## ***Ducted Systems Technical Services Service Letter***

Letter: **YS-001-2020**

Subject: **Blower motor location in belly-band – Regal Beloit Ensight® Blower Motors**

Product: **TM8X, TMLX, TM9X, TM9E, TM9Y, RGF19\*E, RGF29\*E, RGF1L\*E, RGF2L\*E, MM9E**

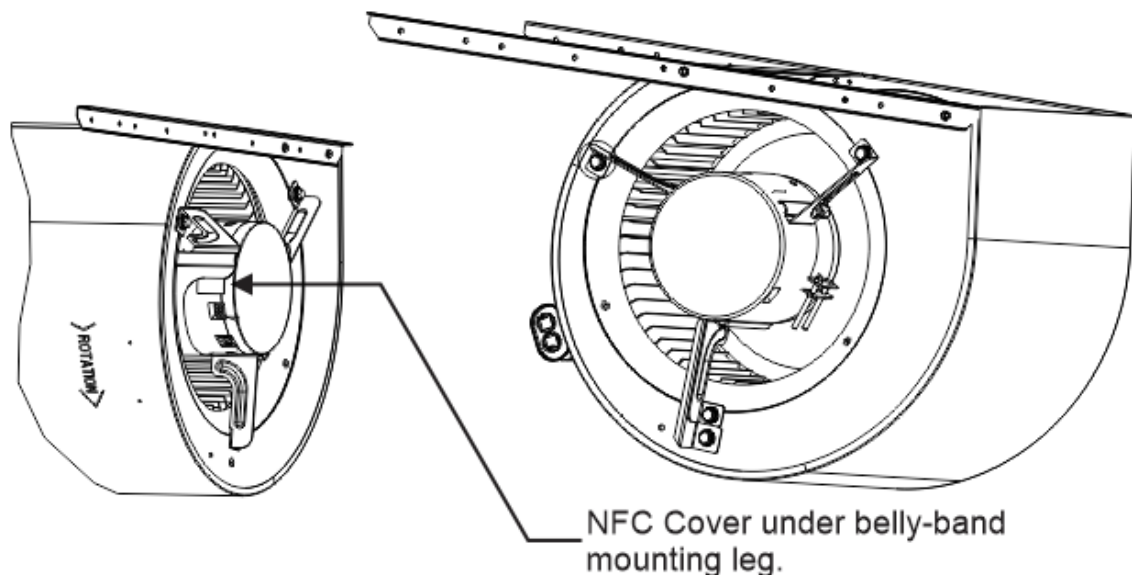
Another reason we found causing excessive blower motor noise is related to some of the motors not being installed correctly in their belly-band mounting assembly during furnace production. The Ensight® motor has a white plastic cover over the NFC programming sensor as shown in the image above. In some cases, the motor belly-band must be relocated/repositioned on the motor. Shown below is an assembly drawing of the motor, belly-band and blower assembly. Notice that the NFC cover is under one of the belly-band mounting legs. When the belly-band is in this position, the motor is not square with the blower assembly and this can lead to excessive noise.

commissioning, the blower motor should be checked to identify if it is an Ensight® motor and then if so, position of the motor in the belly-band as described above. If the motor is in the incorrect location, slide the blower assembly from the furnace, re-locate the motor in the belly-band and re-install the blower assembly. Take external static pressure readings and adjust blower motor speed per the unit installation manual. If excessive external static is present, the customer may need to make duct system modifications.

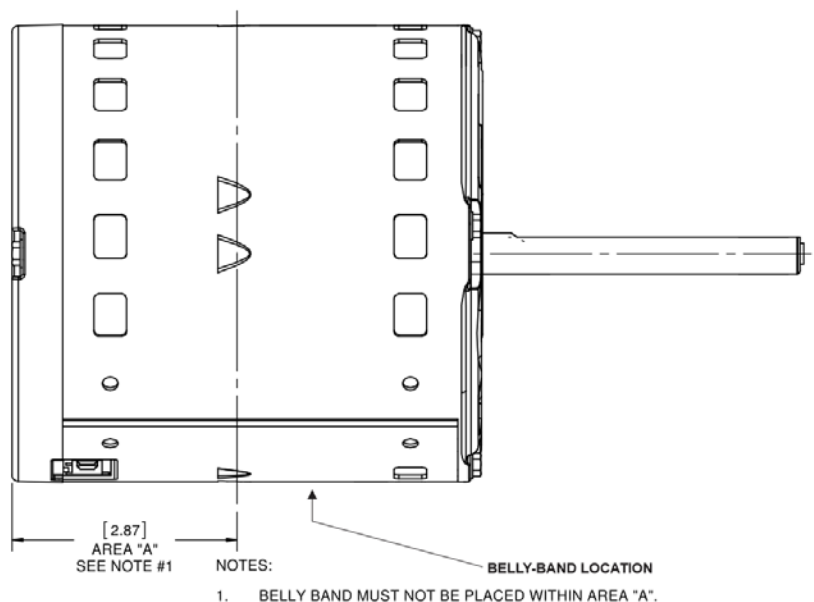
For ½ and ¾ horsepower motors, the belly-band is in the correct location in relationship to the end of the motor (location shown in the image to the right) but the motor must be rotated so that the NFC and electrical connections are in the area where the belly-band clamp bolts are located. Shown below is an assembly drawing of the blower assembly showing the blower motor NFC cover and electrical connections after the motor has been rotated in the belly-band. Notice the connections are in the section of the belly-band where the clamp bolts are located.

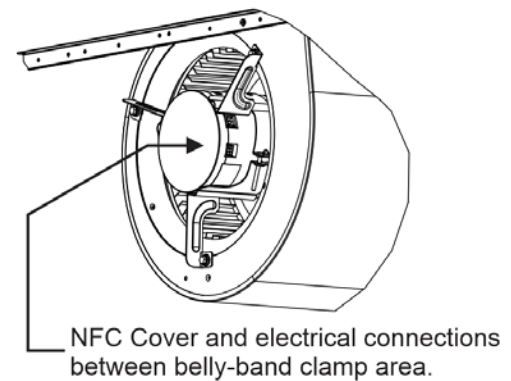
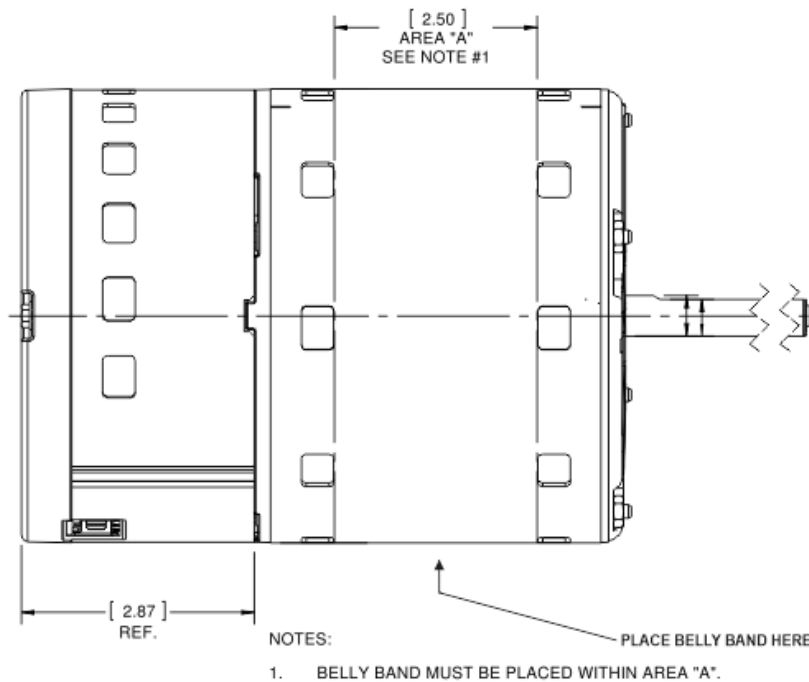
For 1 horsepower motors, the belly band needs to be adjusted so that it is within the appropriate area on the motor. The belly-band must be adjusted toward the shaft end of the motor. Reference the image below showing the correct location of the motor belly-band. The belly-band must be moved into area “A” as shown below.
